ITEM	225-241A Hume Highway, 112 Northcote Road and 24 Hillcrest Avenue, Greenacre
	Demolition of existing structures and construction of a commercial and residential development comprising 177 residential apartments, 14 townhouses, basement and at-grade car parking, new driveway access off Hillcrest Avenue and Northcote Road and associated site landscaping
FILE	DA- 3/2015 (JRPP Reference: 2015SYW018)
ZONING	Part 3(c) – Business Enterprise and Part 2(a) - Residential A
DATE OF LODGEMENT	5 January 2015
APPLICANT	Platinum Design Architects
OWNERS	Bernies Auto Sales (Distribution) Pty Ltd
ESTIMATED VALUE	\$48,863,396
SITE AREA	18,756m²
AUTHOR	Development Services

SUMMARY REPORT

SECTION 79C ASSESSMENT REPORT

FIGURE 12A: Proposed height and setback standards for a development that consolidates the allotments at 225–243A Hume Highway, 112 Northcote Road, and 24 Hillcrest Avenue, Greenacre into a single allotment

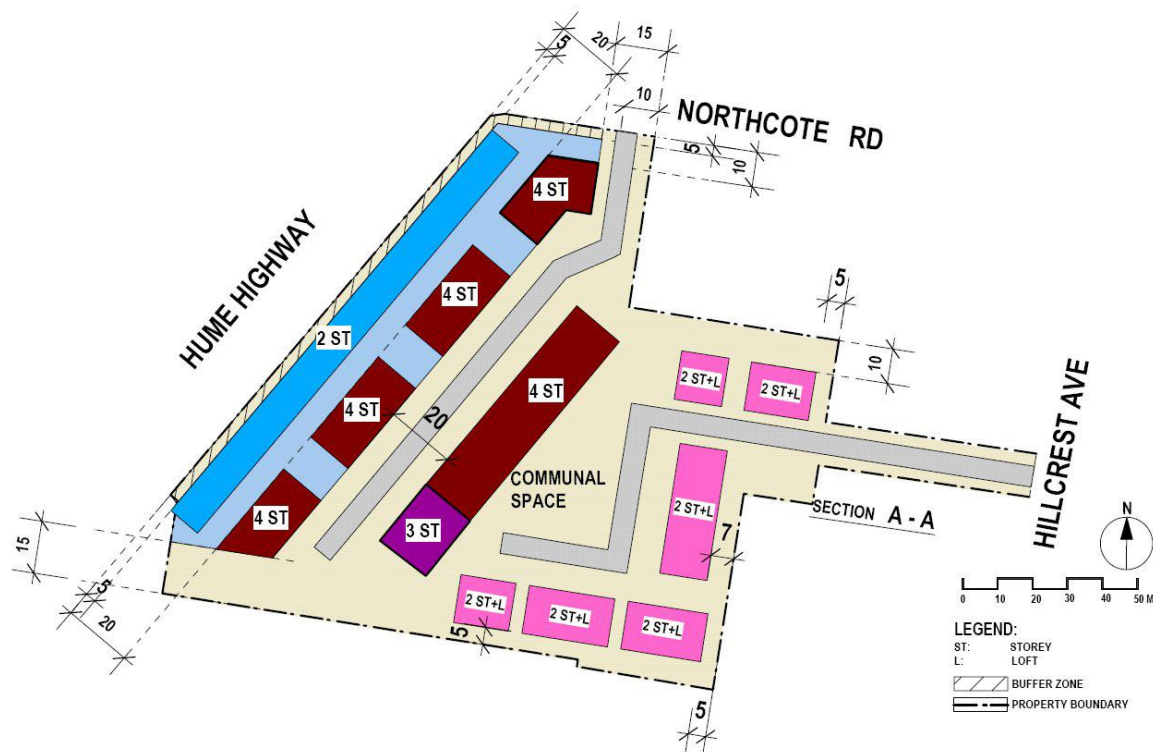
Whilst the portion of the development located within 20m of the Hume Highway boundary is two storeys, the buildings within the rest of the site range from 2 to 3 storey townhouses to 3 to 5 storey residential flat buildings. In particular buildings 4, 5 and the townhouses breach the height control.

The proposed development varies the building layout depicted in Figure 12A, however the building layout maintains the general concept of establishing a defined street edge to the Hume Highway, taller buildings through the central portion of the site, and lower scale buildings to the east and south. The building form reflects the general built form character envisaged for the site and provides for a form, massing and scale that provides for no appreciable loss of amenity for the adjoining residents.

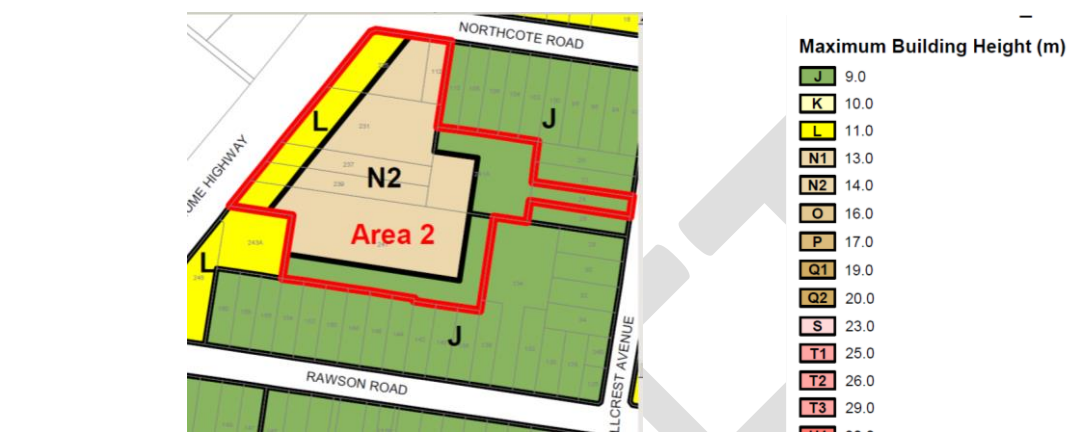
Town Houses – Three townhouses exceed 2 storeys... The portions that exceed 2 storeys are set back 5m from the boundary with the Rawson Road properties and 7m from the boundary with 26 Hillcrest Avenue. A transition in building height from the west to the east to the existing unit complex at 26 Hillcrest Avenue is shown in Figure 5. The shadow impact of the third level ... is reasonable as:

- The shadow impact of the townhouses do not impact the principle buildings on adjoining properties between 10am and 1pm (3hours) on winter solstice. All adjoining properties, individually received at least 4hours direct sunlight.*
- Shadows of the townhouses predominantly fall on sheds and garages located at the rear of backyards of Rawson Road properties.*
- The units at 26 Hillcrest Avenue are shaded by existing trees and have limited fenestration on the facades facing the site.*

The townhouses that are three storey provide for ground floor car parking, first floor living areas and upper floor bedrooms. To ameliorate potential overlooking / privacy issues arising from the upper floor living rooms and top floor bedrooms, it is recommended that the windows / openings provided along the rear elevations of these townhouses to have a minimum sill height of 1.7 metres. Required solar access to the adjoining developments and their rear yards is achieved despite the breach to the storey limit.
